STANDARD DEPARTURE CHART-INSTRUMENT

RJFN / NYUTABARU

NIPPO SEVEN DEPARTURE

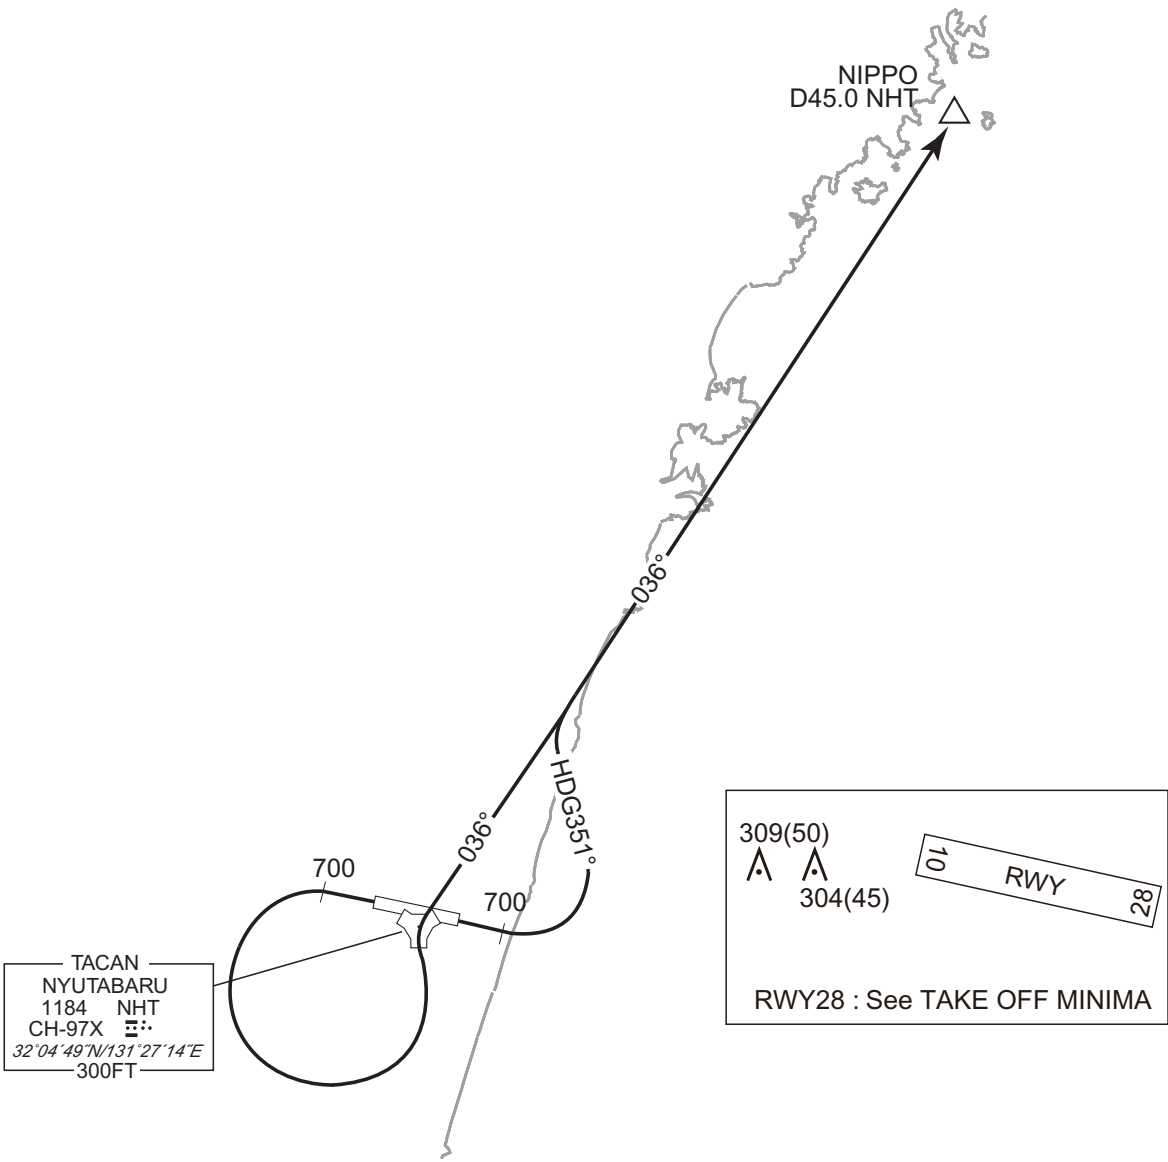
CHANGE : PROC renamed(NIPPO SEVEN DEPARTURE). PROC course(NIPPO SEVEN DEPARTURE). YATOJI TWO DEPARTURE abolished.
Restriction. Note, OBST added.

TENSO FOUR DEPARTURE

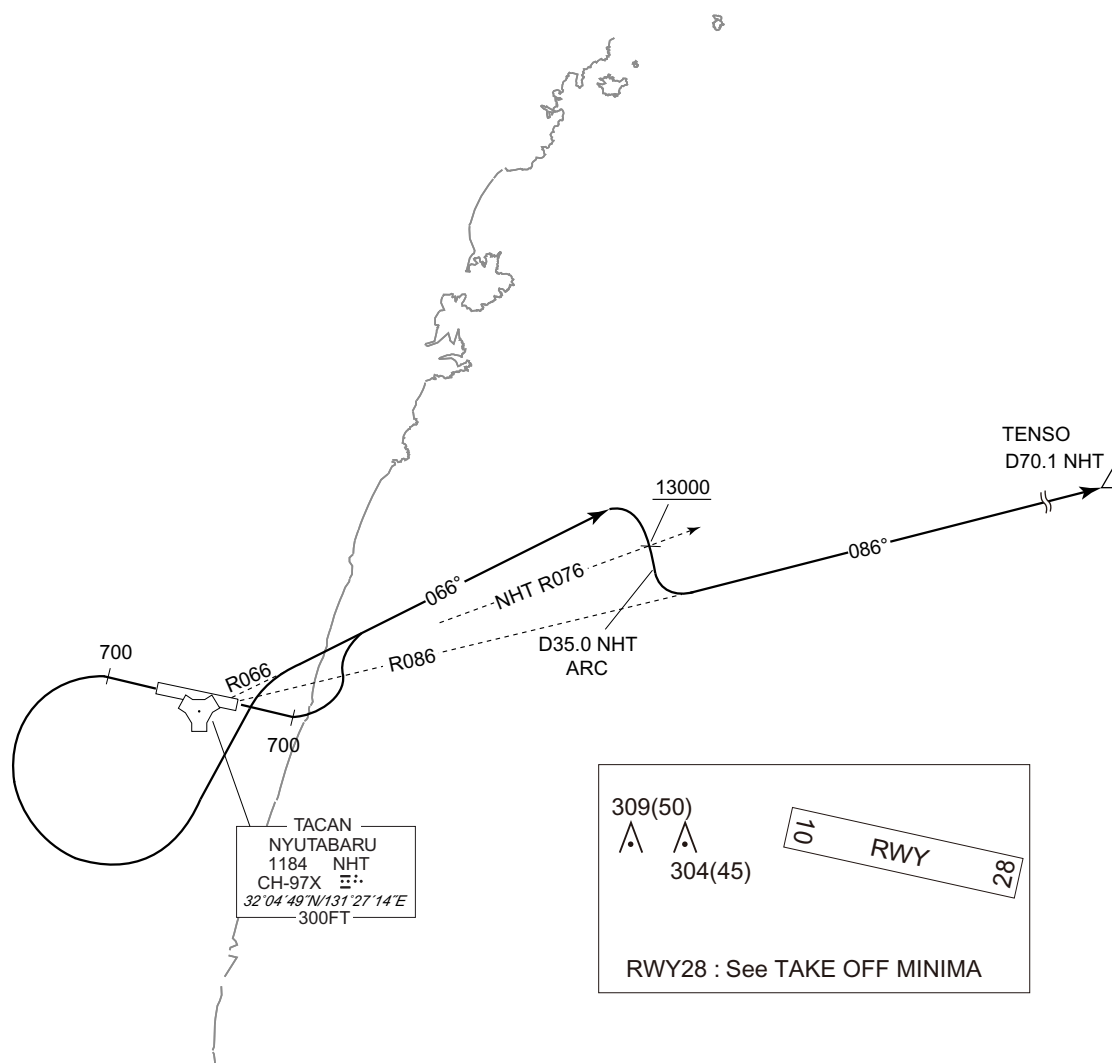
CHANGE : PROC renamed. PROC course. Restriction. Note, OBST added.

SAITO ONE DEPARTURE

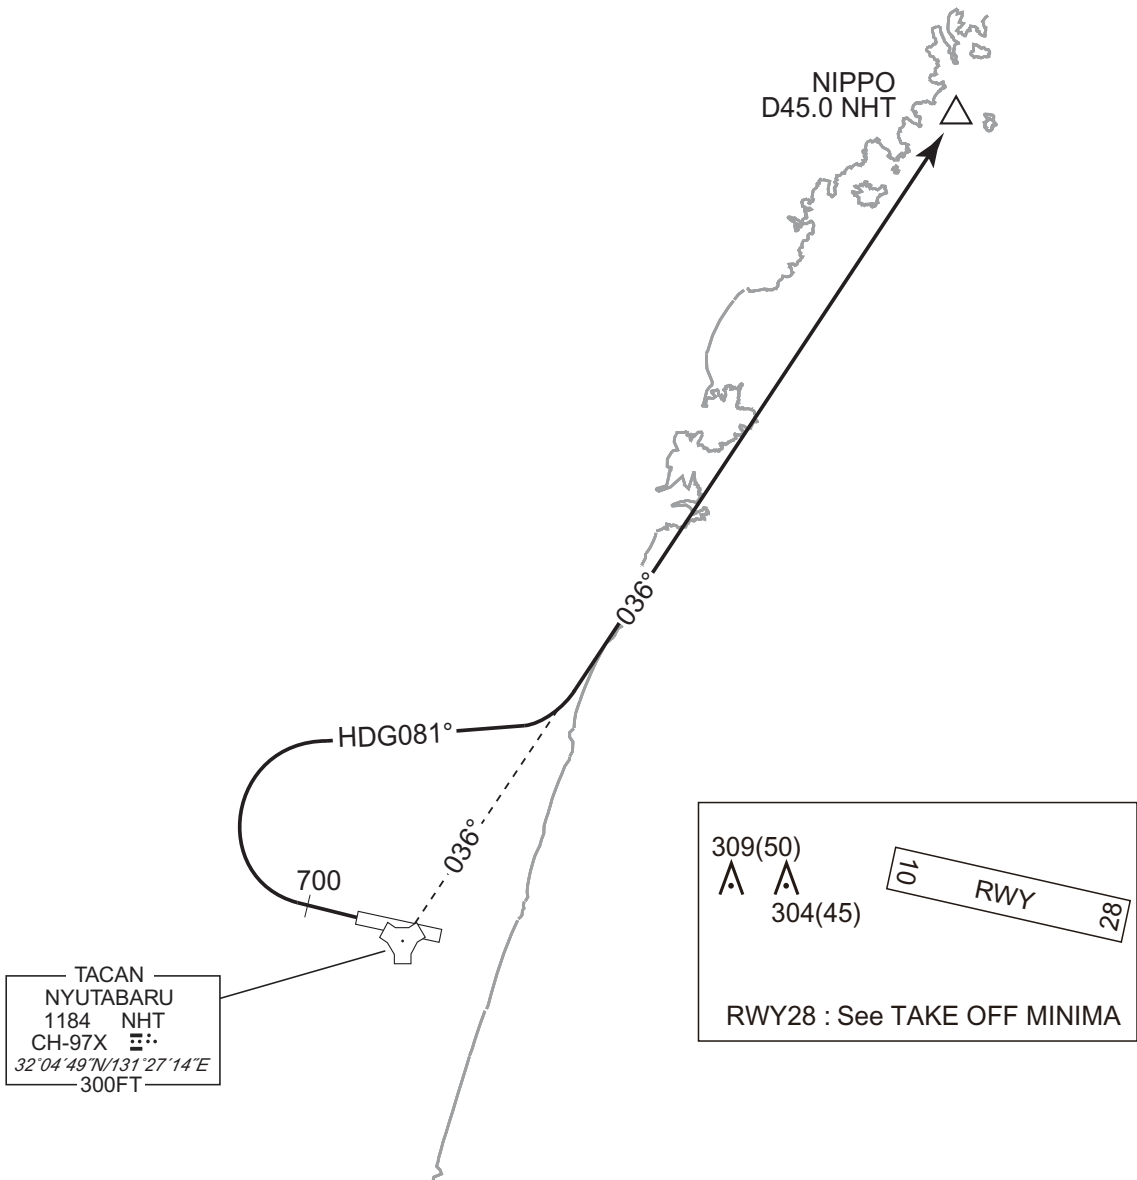
CHANGE : New PROC.

TRANSITION

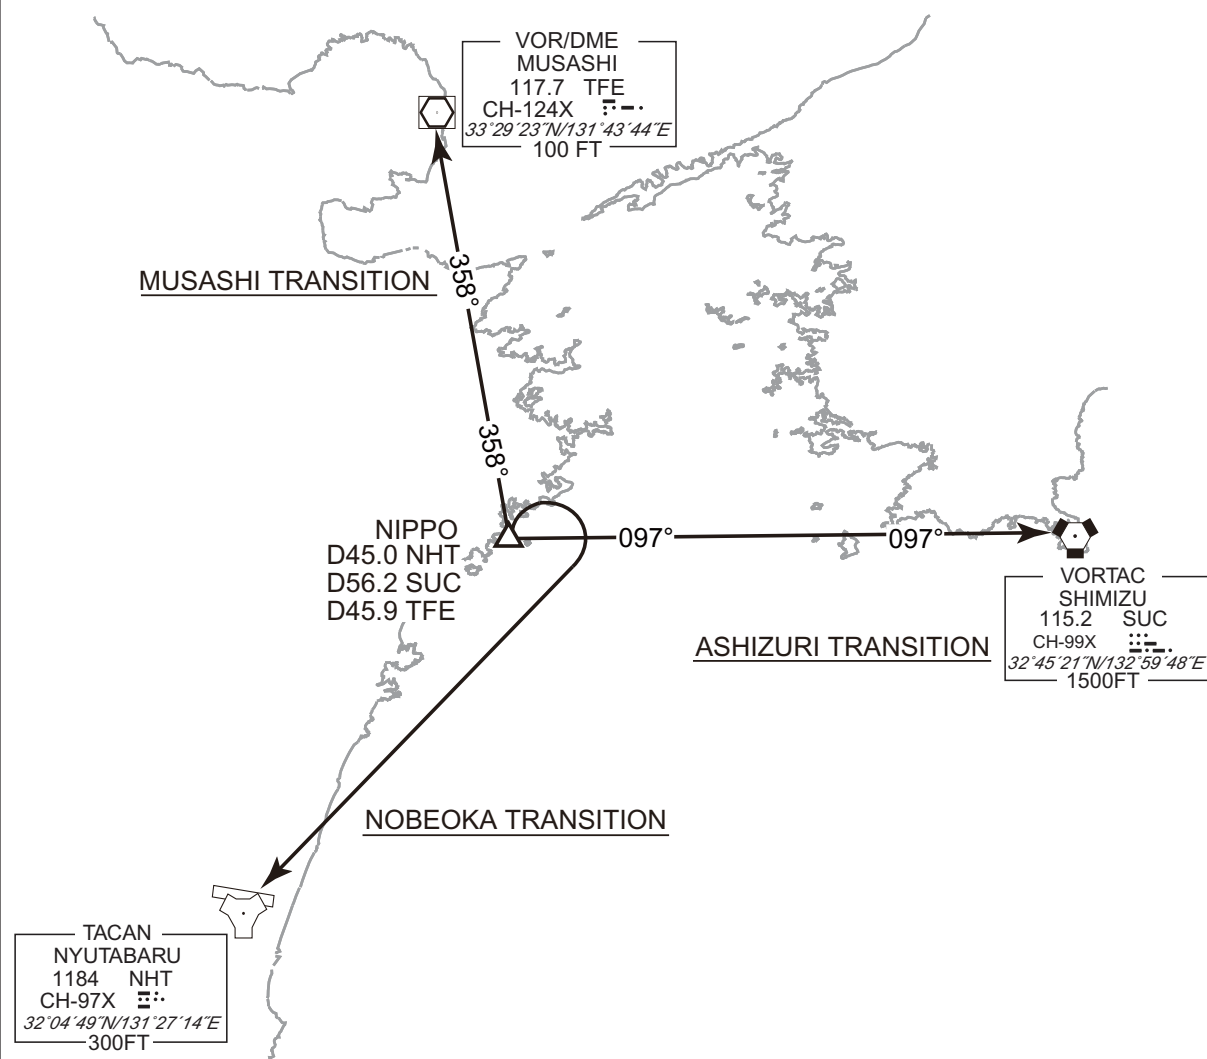
CHANGE : PROC course(NOBEOKA TRANSITION). Description of ASHIZURI TRANSITION, MUSASHI TRANSITION, MUSASHI TRANSITION. ALT restriction.
SOBO TRANSITION abolished.

TENSO ARRIVAL

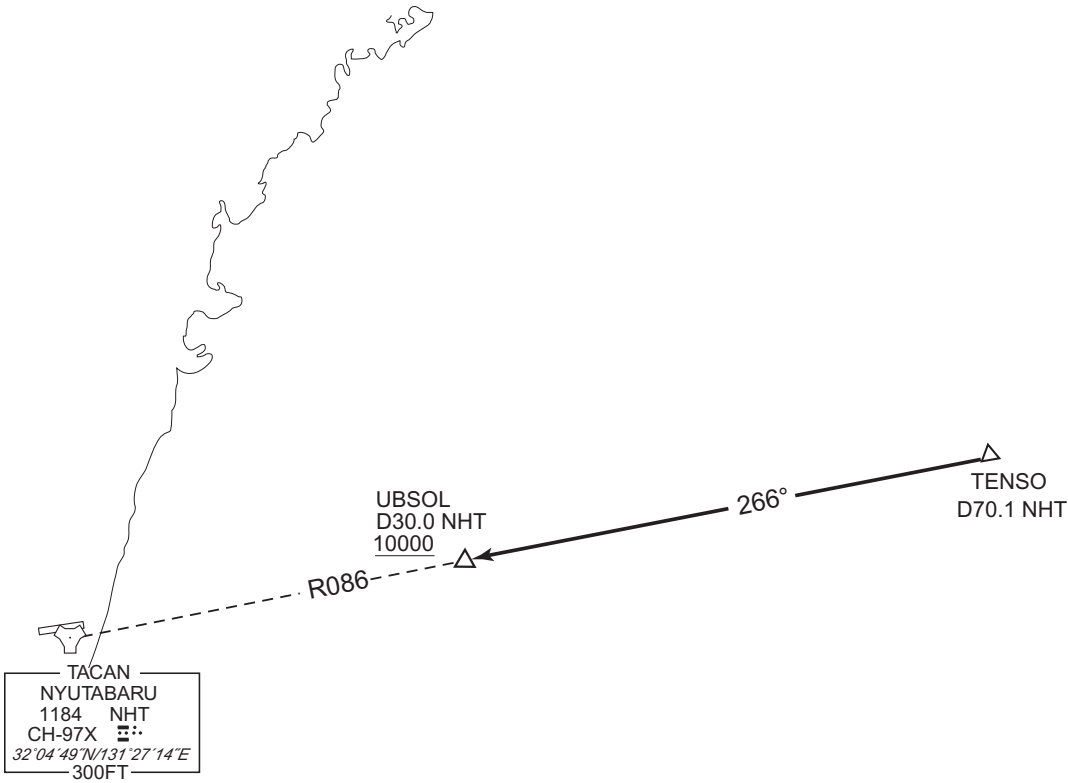
CHANGE : PROC course. UBSOL established. ALT restriction.

TACAN Z RWY28

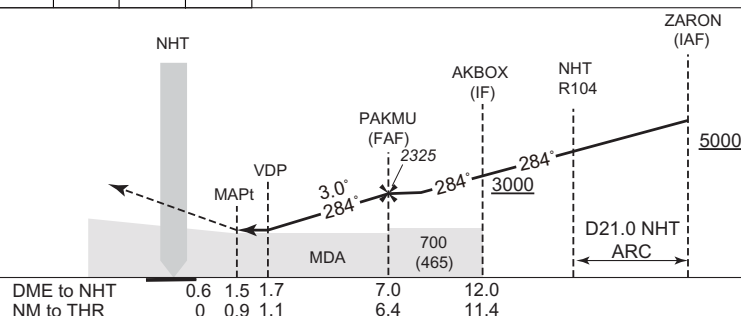
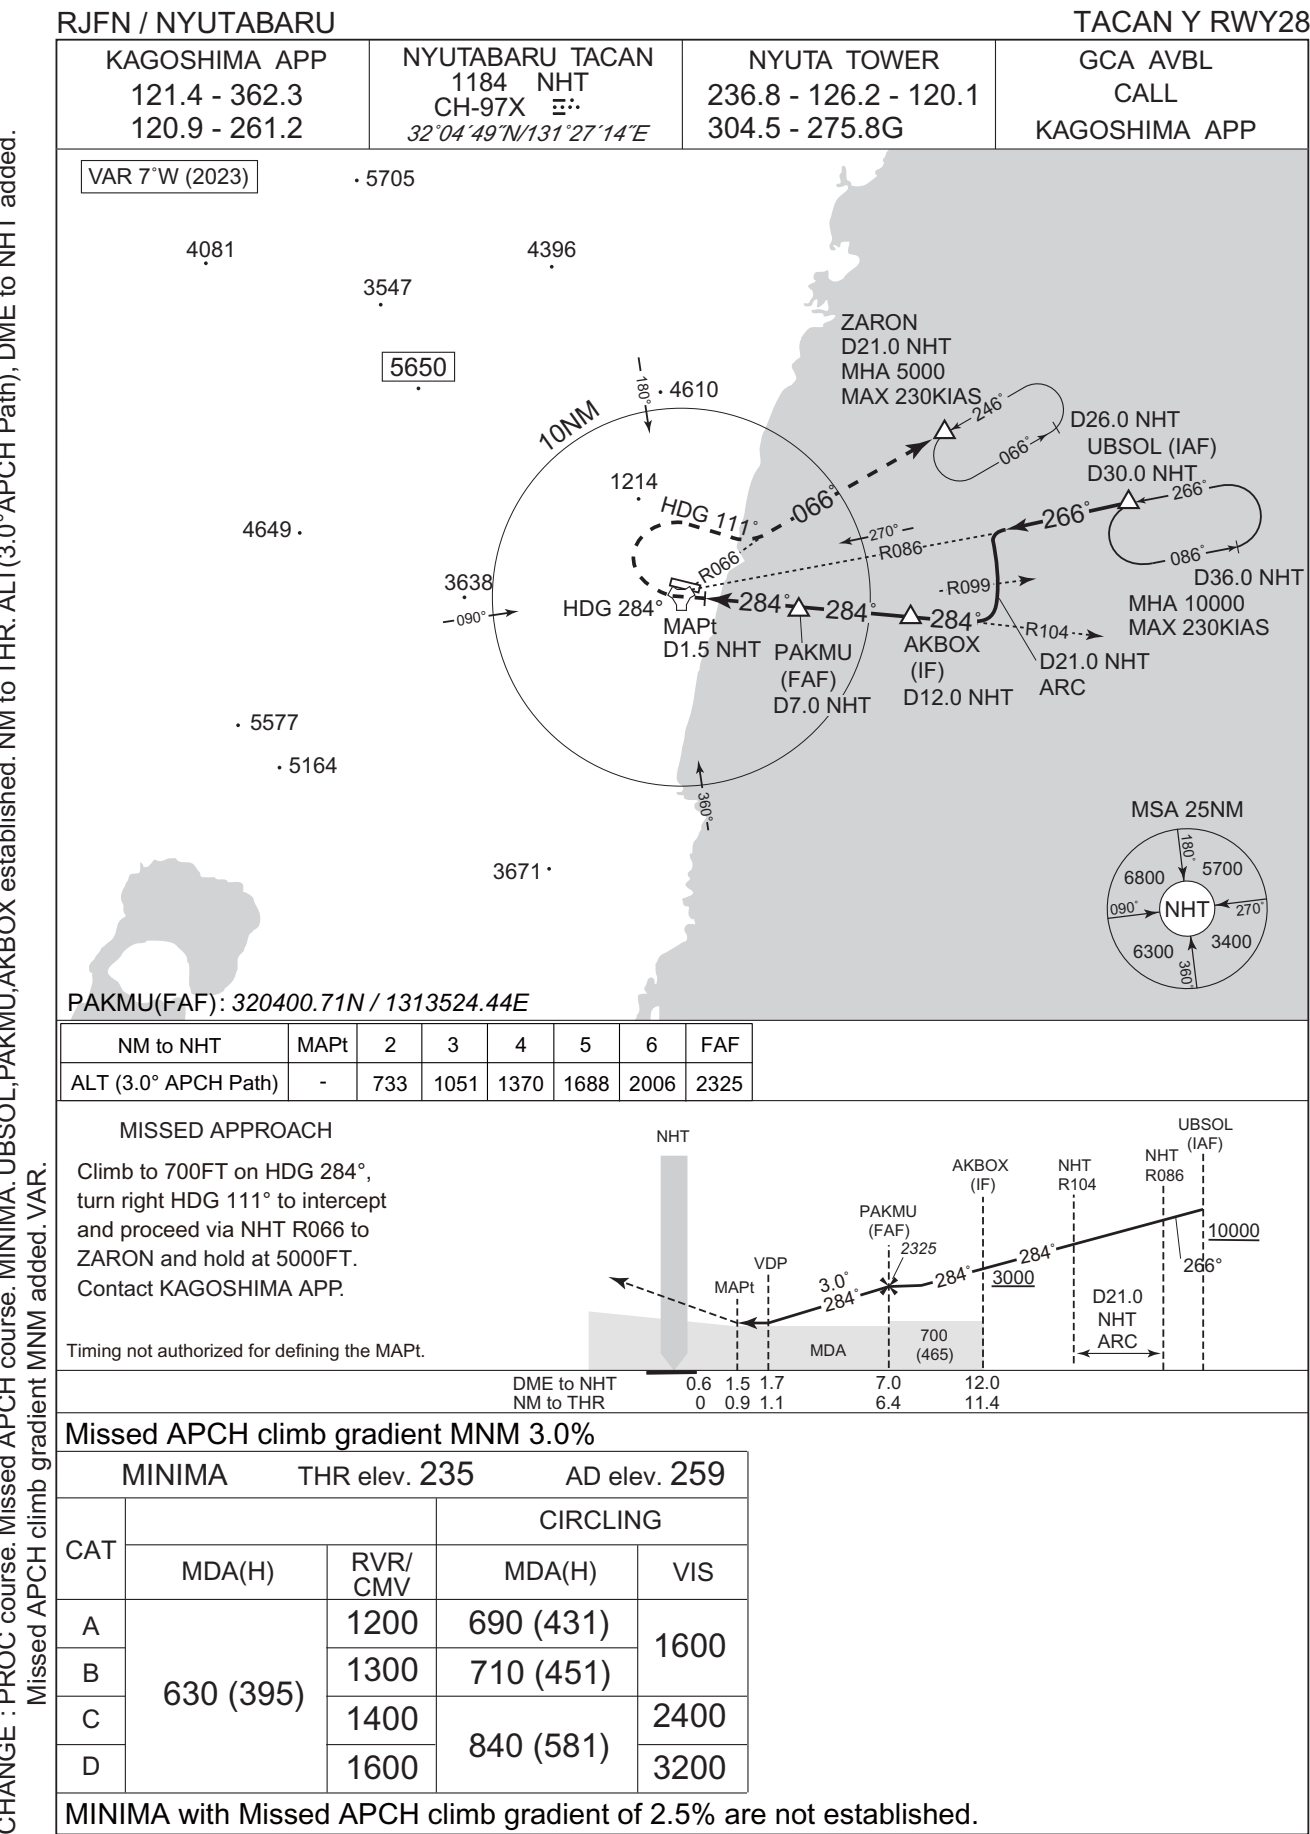
CHANGE : PROC course. Missed APCH course. MINIMA. PAKMU,AKBOX established. NM to THR. ALT (3.0°APCH Path), DME to NHT added. Missed APCH climb gradient MNM added. VAR.

ILS Y or LOC Y RWY28

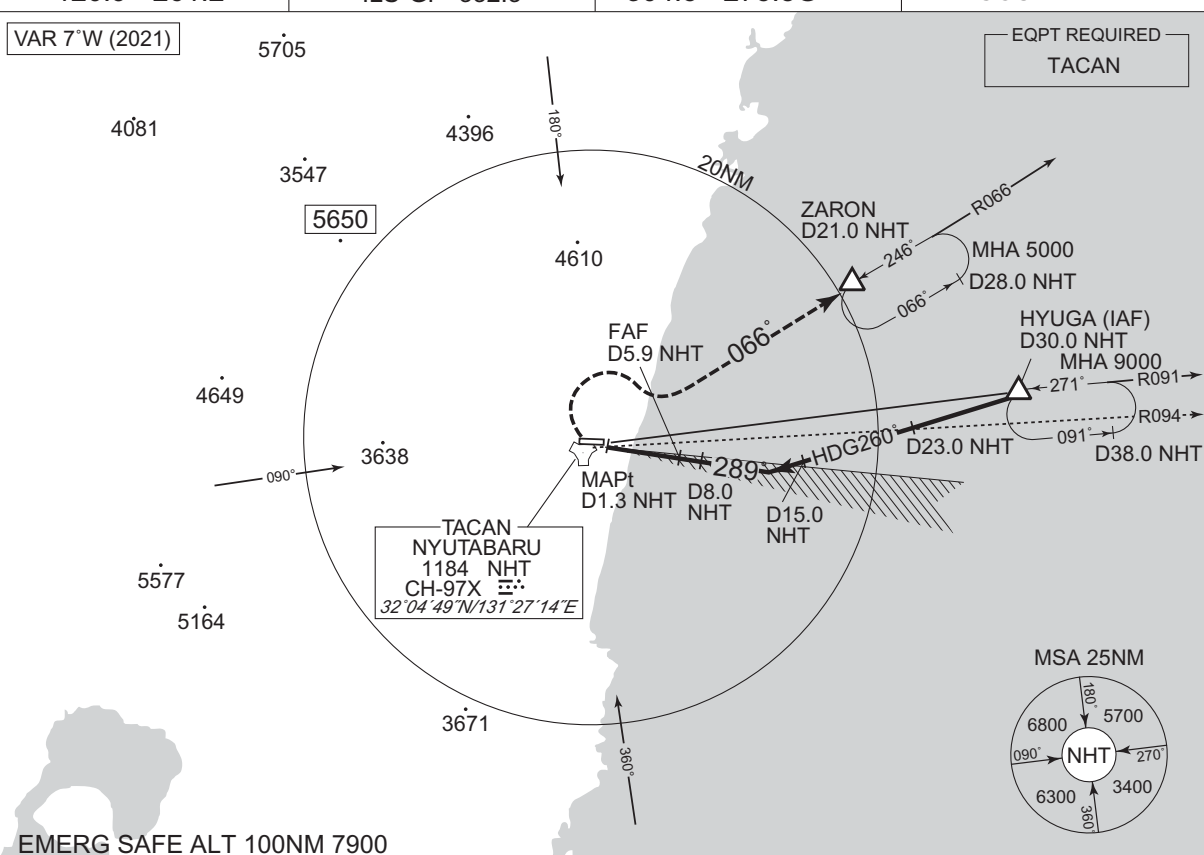
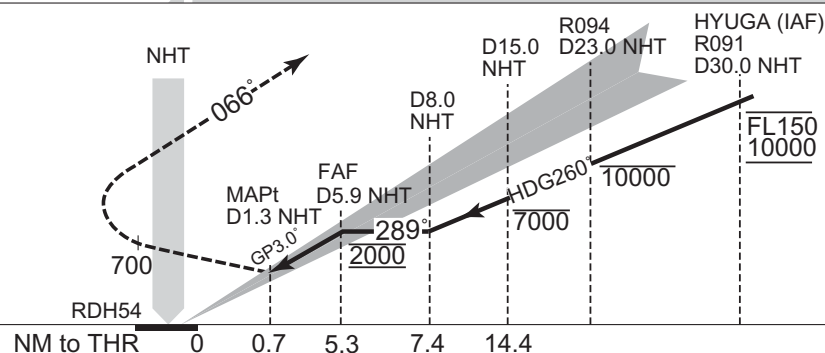
CHANGE : VAR. PROC renamed. EQPT REQUIRED added. PROC course. MISSED APPROACH course. MSA.
NM to THR added. MDA(H) for CIRCLING.
